Subject: Driveway alignment for the proposed on-site parking lot serving the future Wilsonville TOD affordable mixed-use project at 9749 SW Barber St, Wilsonville OR, 97070 (DB23-0011).

Wilsonville TOD

Please accept this request for an Alternative Design & Construction Standard to Section 201.2.23(h) of the Public Works Standards, regarding driveway alignment for the on-site parking lot serving the Wilsonville TOD project. This project is currently under review by the City of Wilsonville Planning Department (DB23-0011). This Public Works Standard requires driveways that intersect an existing Collector Street align with existing opposing streets or major driveways, unless topography, existing features, or geographic conditions prohibit this alignment. We request that the proposed driveway is allowed to be offset ~22'-6" (centerline to centerline) from the existing driveway across the street on the south side of SW Barber Street. This Alternative Design is needed to provide vital functions of the project and to protect three existing trees that are crucial to the character of the project.

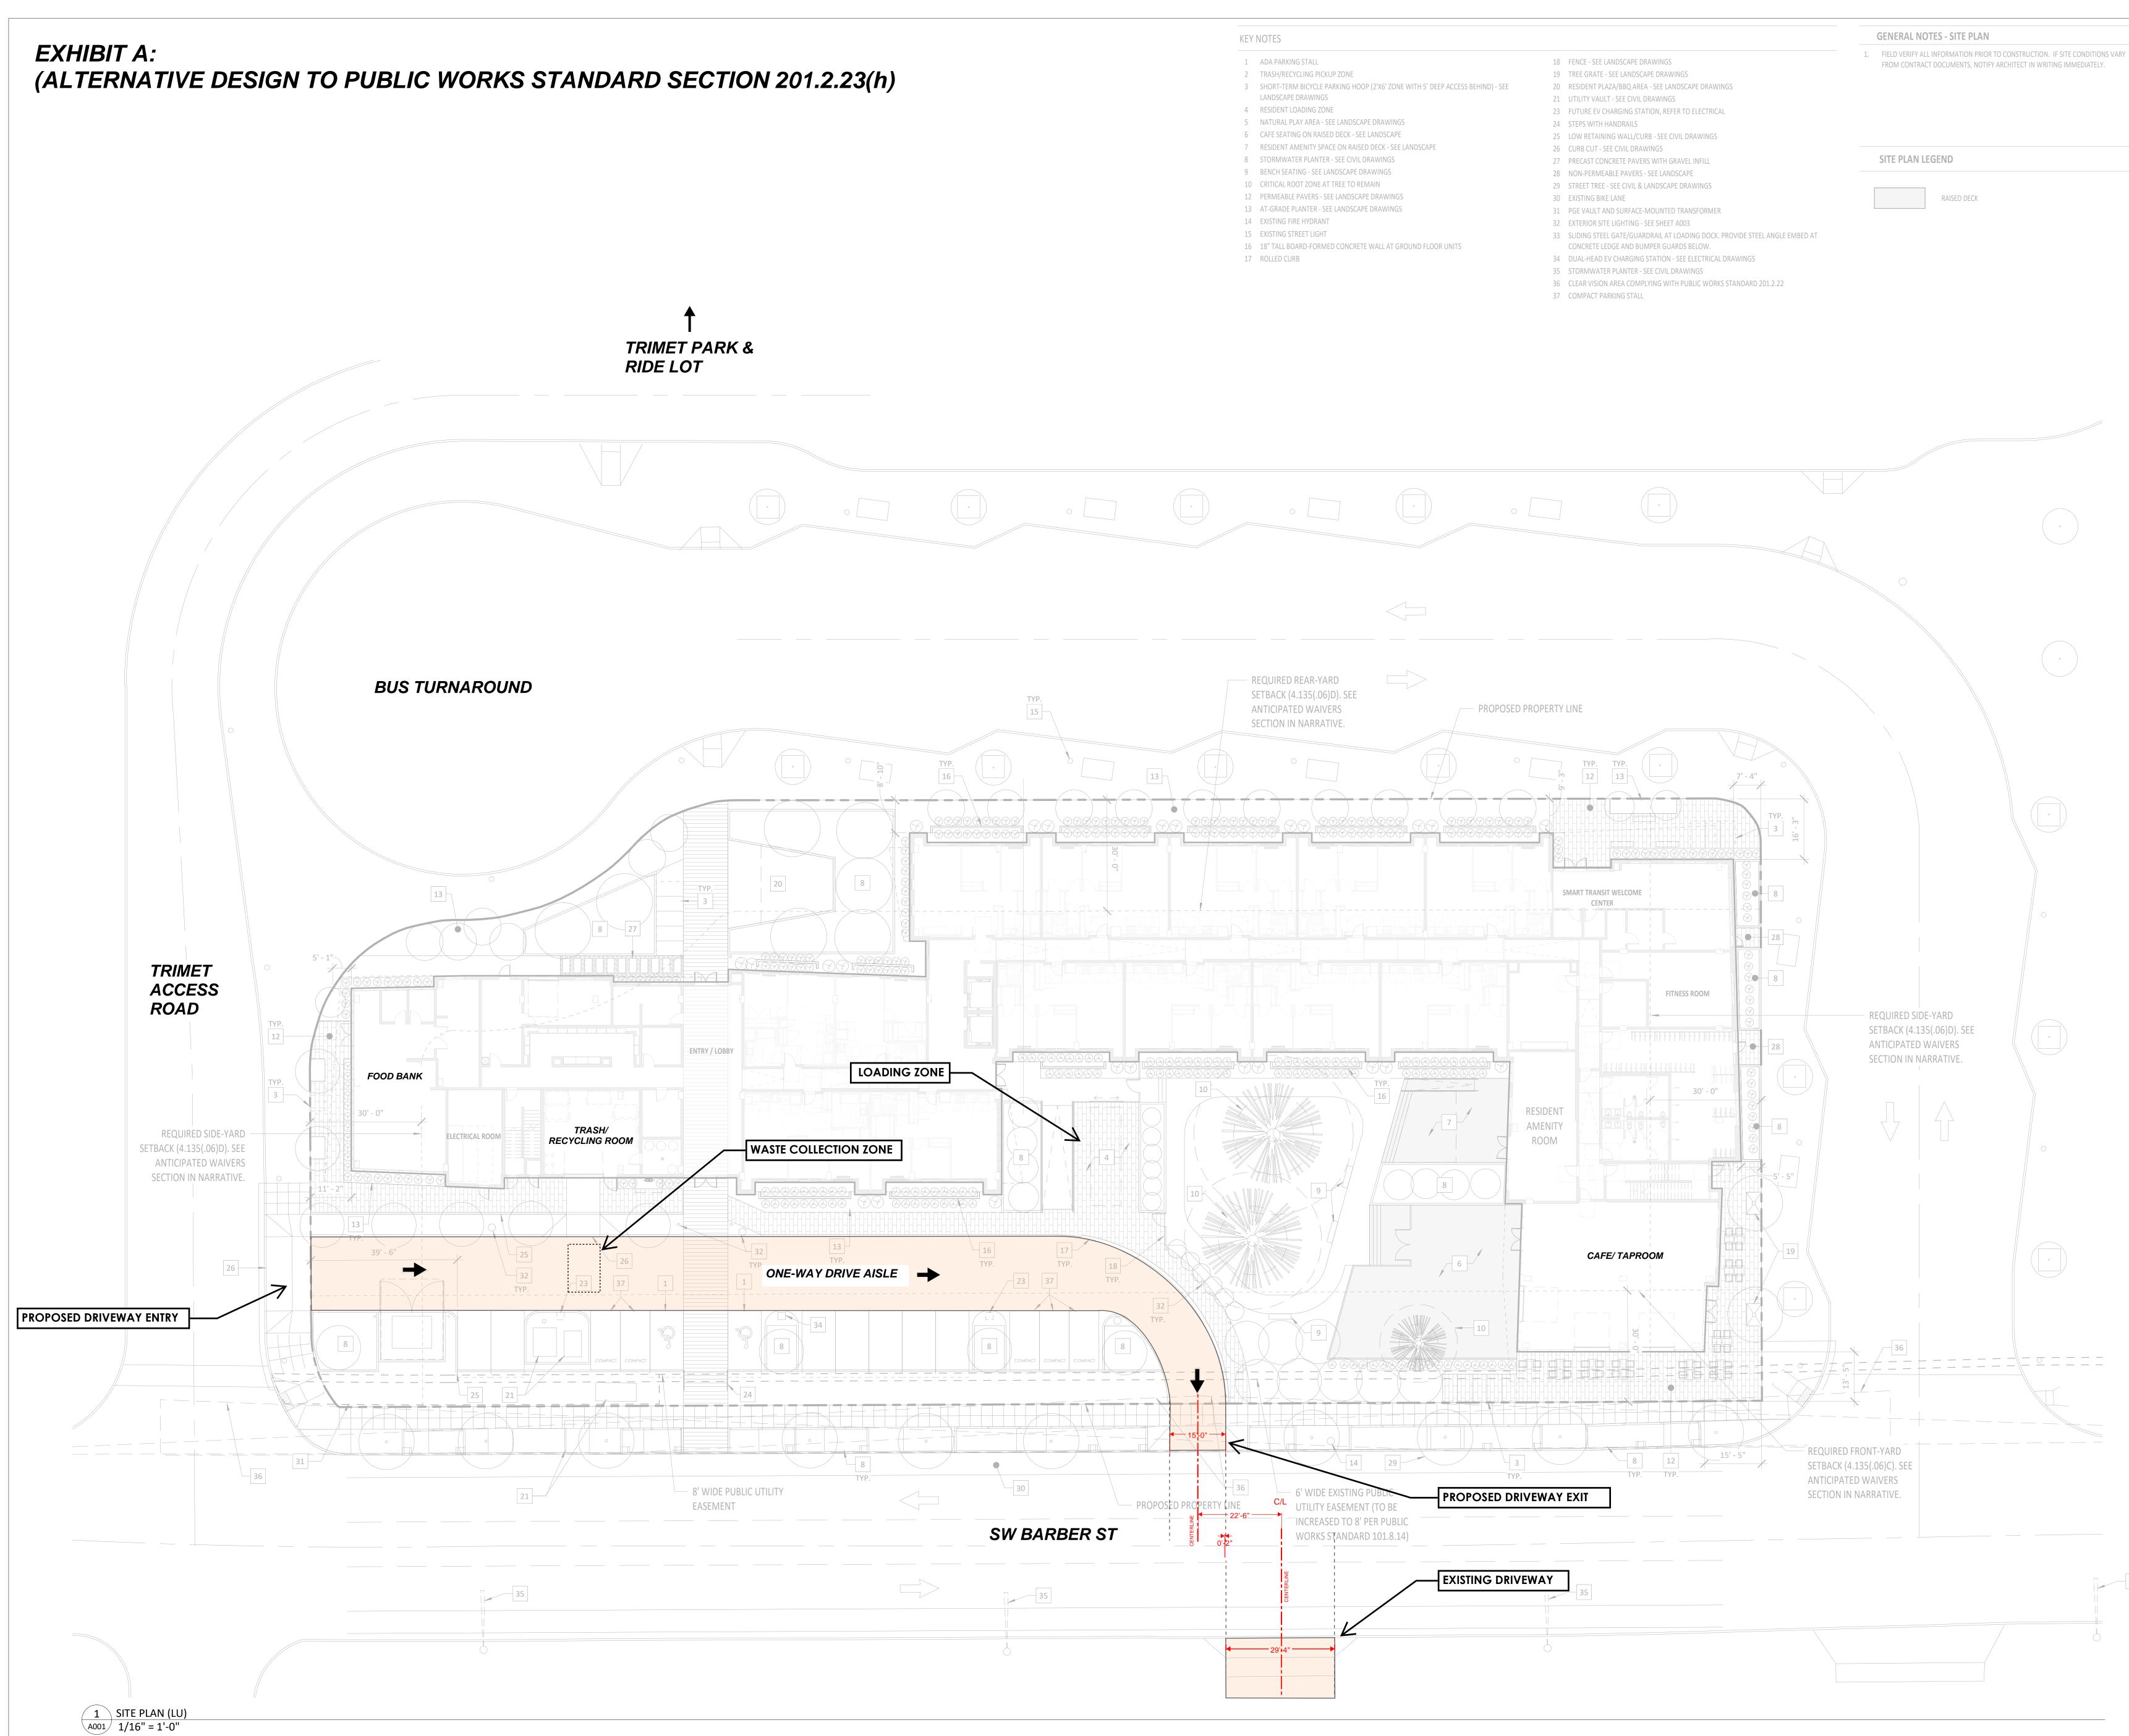
The design team has revised the site plan to achieve closer alignment of the new driveway with the existing driveway across Barber, while still maintaining the health of the existing trees. The original proposal showed a ~36'-6" offset of the driveways (centerline to centerline), while the revised proposal is for a ~22'-6" offset (centerline to centerline). This results in the edge of the new proposed driveway being only ~2" offset from the edge of the existing driveway. Please refer to Exhibit A included with this letter, illustrating the proposed offset.

Due to the importance of retaining the existing trees and providing a functional drive aisle for convenience parking, essential site functions, and garbage and recycling collection, as well as the absence of any safety concerns regarding the driveway offset in the Traffic Analysis, we kindly request that an Alternative Design to Public Works Standard 201.2.23(h) be granted to allow the proposed offset of the driveway.
